# SERVICE BULLETIN

No. 481A

Piper Aircraft Corporation

Subject: Elevator Assembly Inspection and Elevator Butt Rib Replacement.

SKETCH A

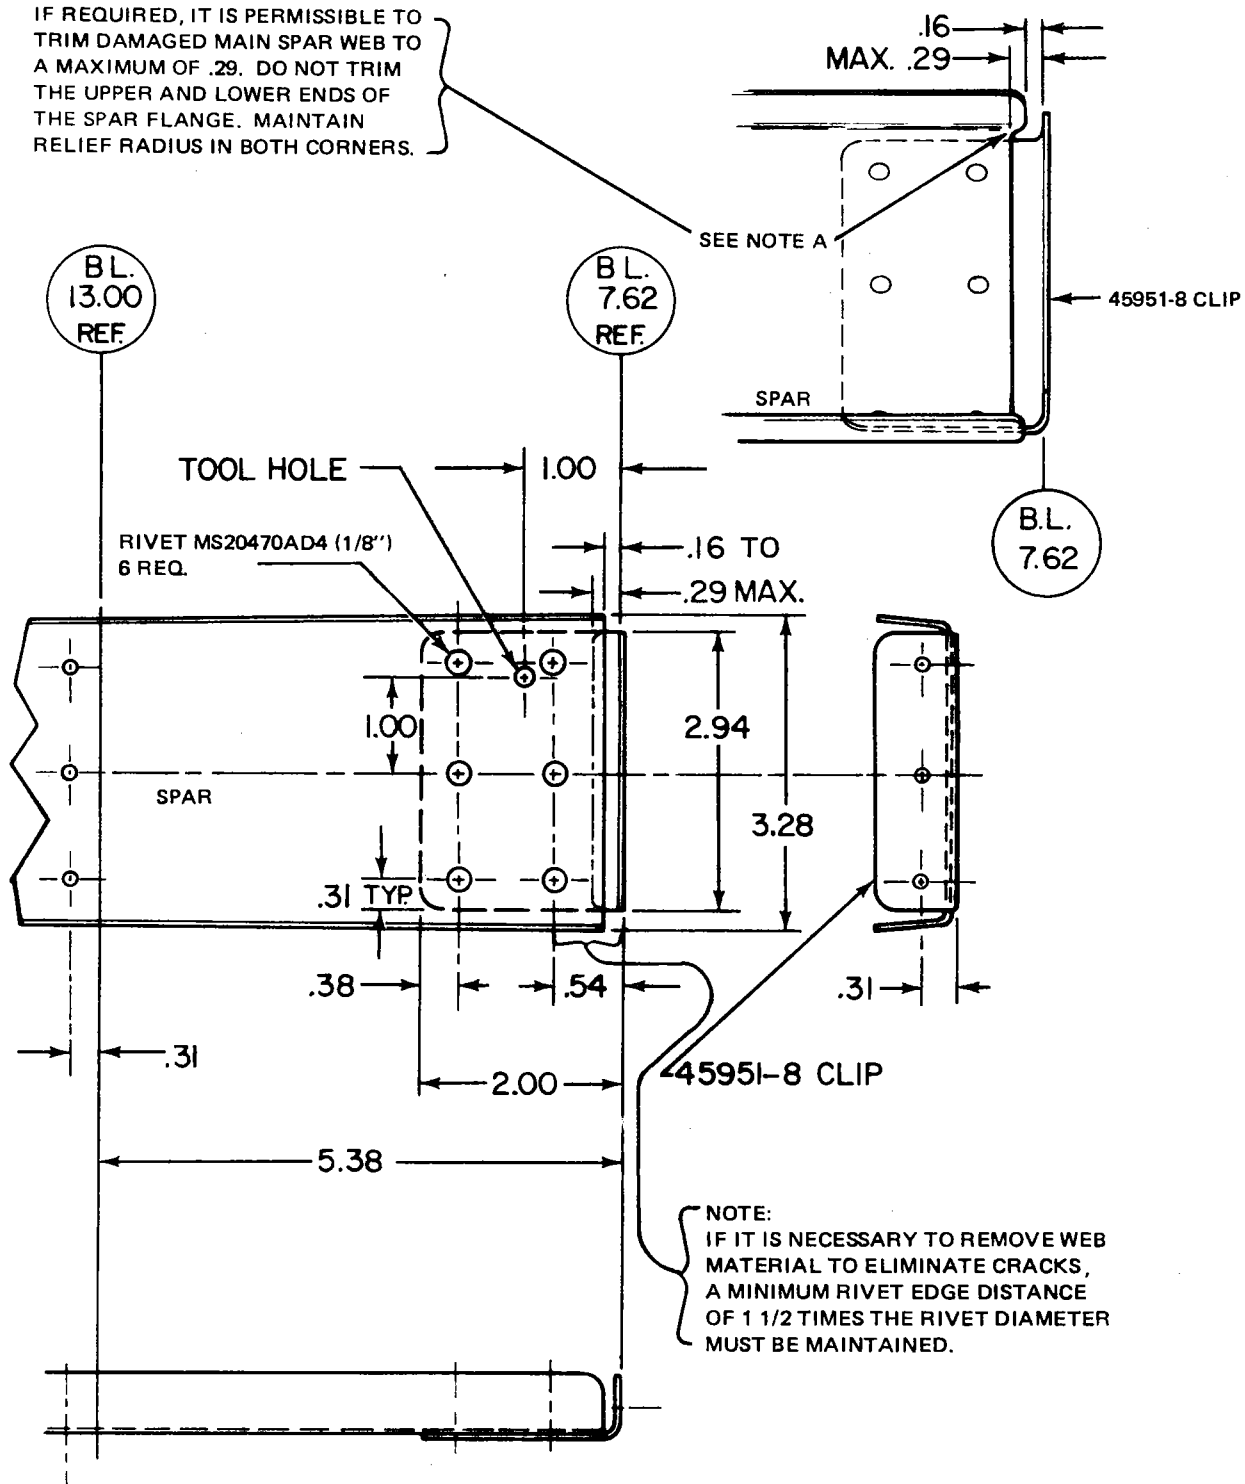
1. Remove Elevators, reference current PA-31T Service Manual, Section IV, Structures.
  2. Reference attached sketch "A"; remove existing Elevator Butt Ribs, part number 45933-04 and discard. CAUTION: Remove elevator identification plate (stamped metal tag with elevator part number, serial number, etc.) and stamp with letter "S" for revision. Retain for reinstallation on new Elevator Butt Ribs; reference step 6, below.
  3. Reference attached sketch "A"; with concentrated light, inspect inboard end of Elevator Main Spar, part number 45951-06, and Channel ("false spar") part number 45807-00 for cracks around bolt hole perimeters and in flange bend radii.
-

- a. If cracks are found in Elevator Main Spar Tab, remove tab and replace with clip Piper part number 45951-08 as shown on the attached illustrations (sketch "A" and "B").

NOTE A  
IF REQUIRED, IT IS PERMISSIBLE TO  
TRIM DAMAGED MAIN SPAR WEB TO  
A MAXIMUM OF .29. DO NOT TRIM  
THE UPPER AND LOWER ENDS OF  
THE SPAR FLANGE. MAINTAIN  
RELIEF RADIUS IN BOTH CORNERS.

SKETCH D

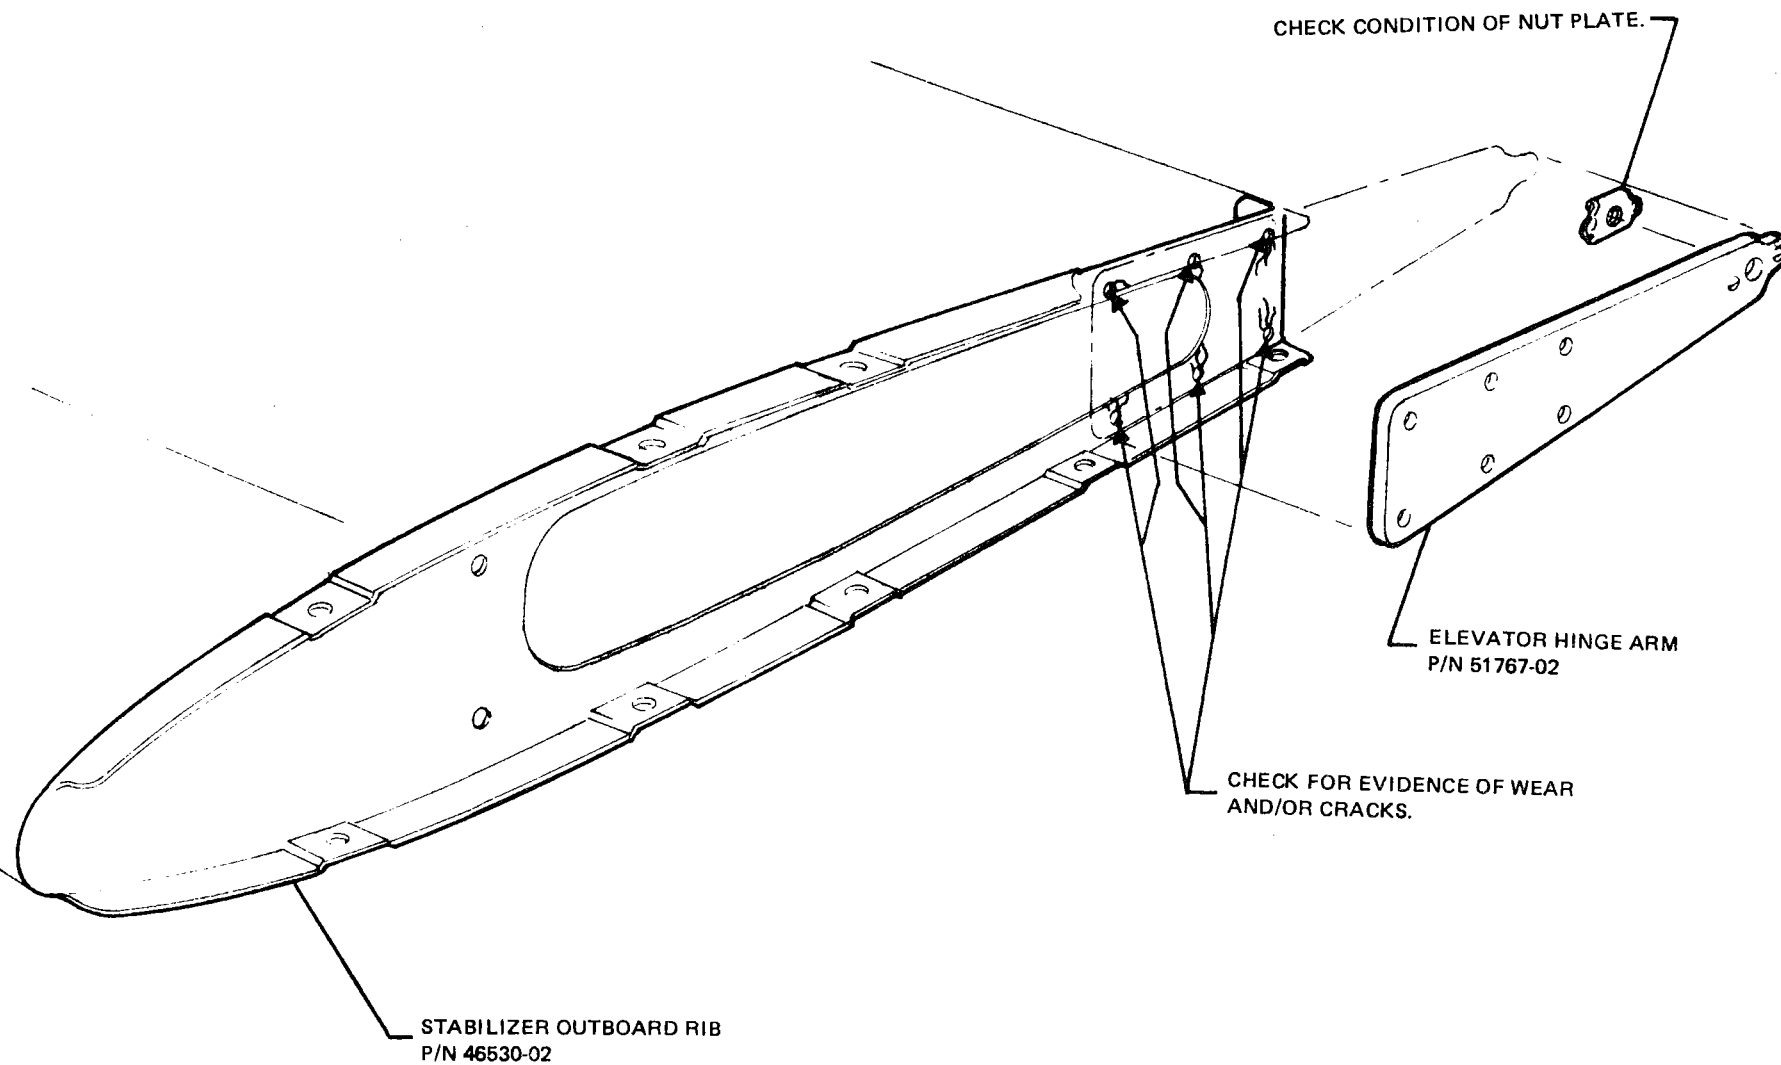
- c. Reinstall elevator tip.
5. Remove stabilizer tip (reference sketch "D");
  - a. Inspect Stabilizer Outboard Rib, Piper part number 46530-02 (aft, near the hinge attachment point and Elevator Hinge Arm Assembly, Piper part number 51767-02 for evidence of wear and/or cracks; if loose and/or cracked, replace.
